**ADDENDUM NO. 2
INVITATION TO BID #16-022
WINDSOR PARKWAY DETENTION POND PROJECT**

WINDSOR PARKWAY DETENTION POND
SANDY SPRINGS, GEORGIA
CITY OF SANDY SPRINGS

EXCAVATION BRACING

EX1

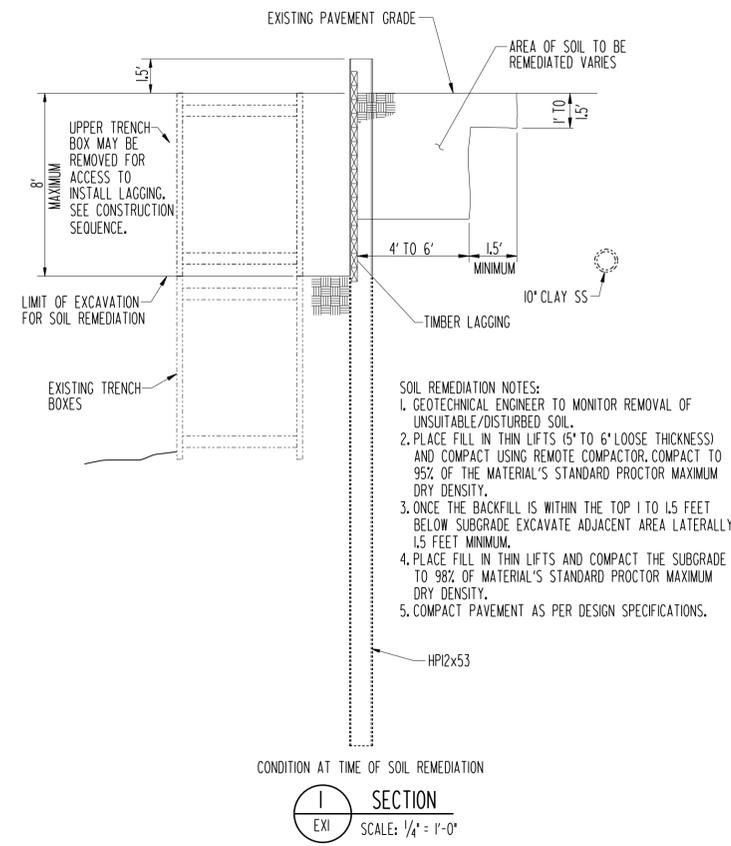
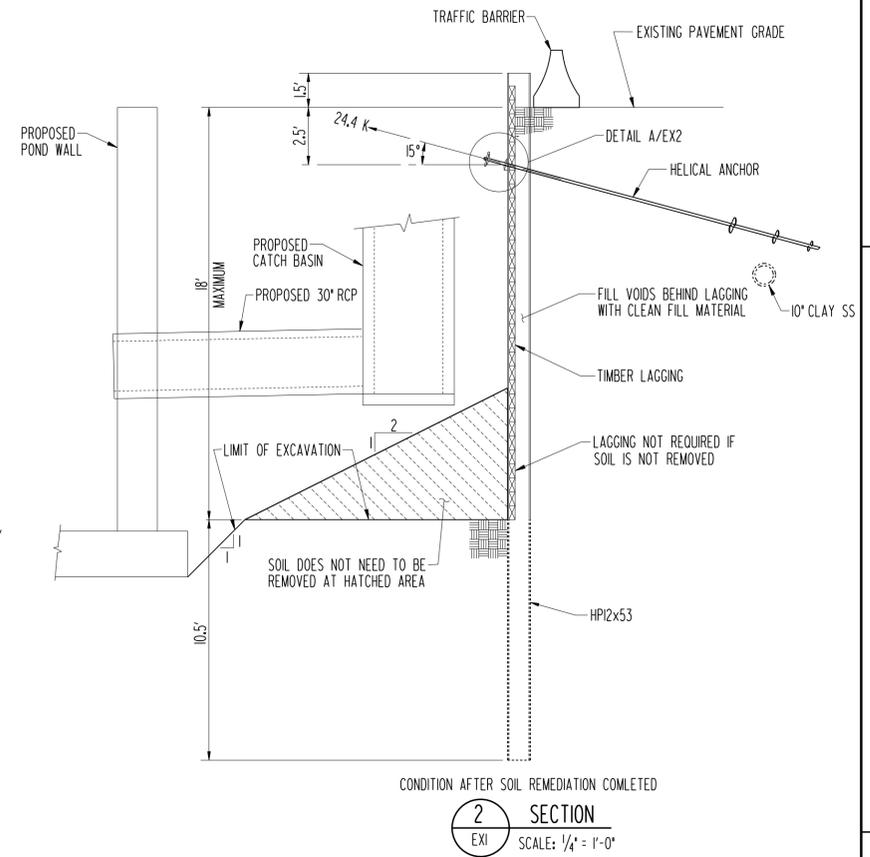
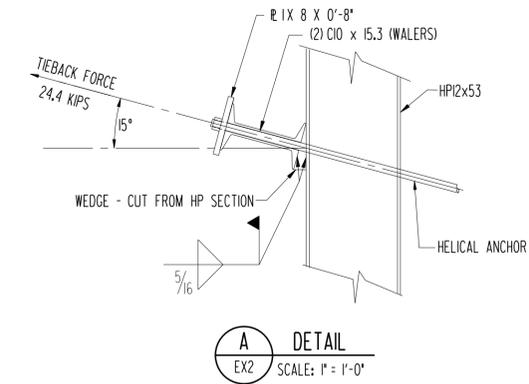
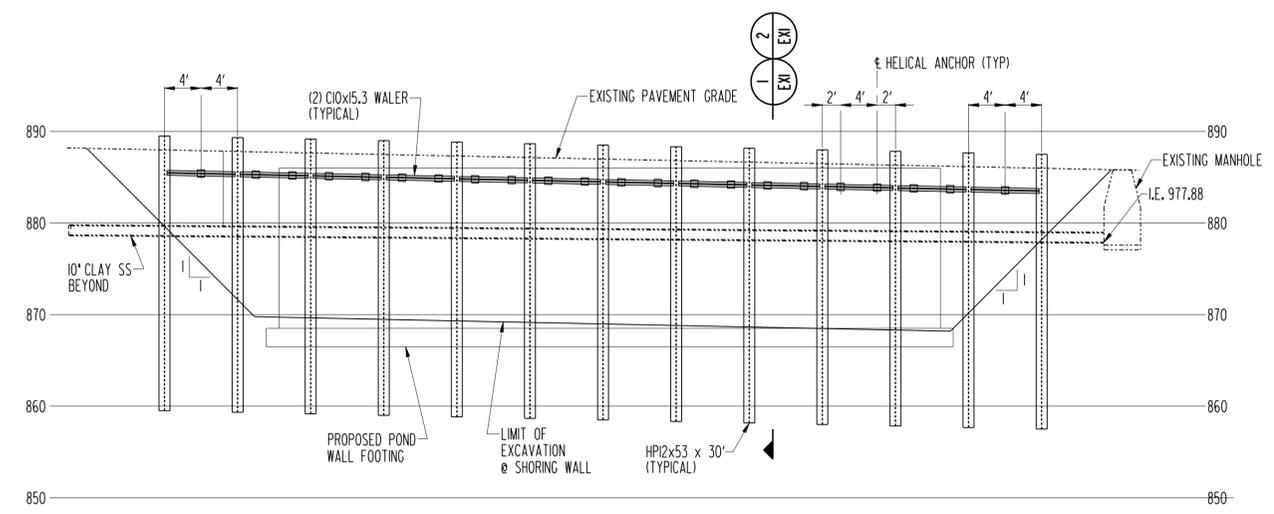
10. Assuming existing soil having to be removed from existing shoring side of project for compaction purposes, has this been taken in to account for existing shoring design and install or should we assume further means of protection of fear of it failing? **Shoring plan attached for reference.**

- REMEDiate SOIL BEHIND WALL THAT WAS AFFECTED BY FAILURE OF ORIGINAL SHORING SYSTEM. SEE SOIL REMEDIATION NOTES IN SECTION 1/EX1.
 - INSTALL TIEBACKS. LOCK OFF TIEBACKS AT LISTED TIEBACK FORCE (SEE DETAIL A).
